PCN#20181205001.0

**Pin One Dot Symbolization change – Adding Pin One Dot for Select SC70, SOT-23,
and SOT-223 Devices
Information Only**

Current Symbolization (No Pin One Dot)	New Symbolization (With Pin One Dot)
SC70 Example		
SOT-23 3 Lead example		
SOT-23 5 Lead example

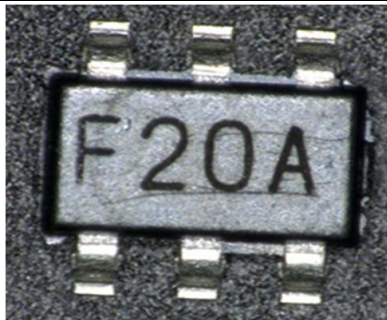
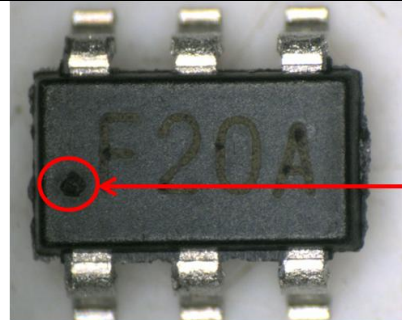
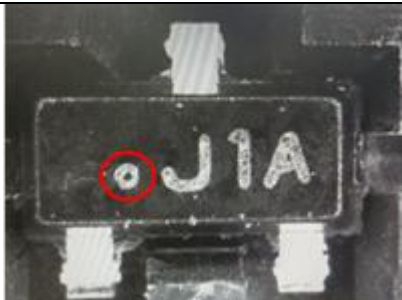
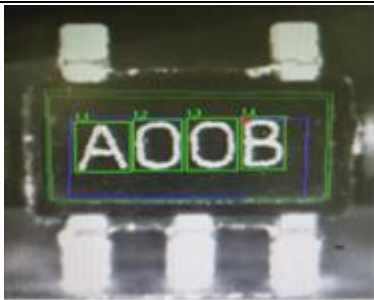
This letter is to inform of the addition of a Pin One dot in the devices symbolization of select SC70, SOT-23, and SOT-223 Devices:
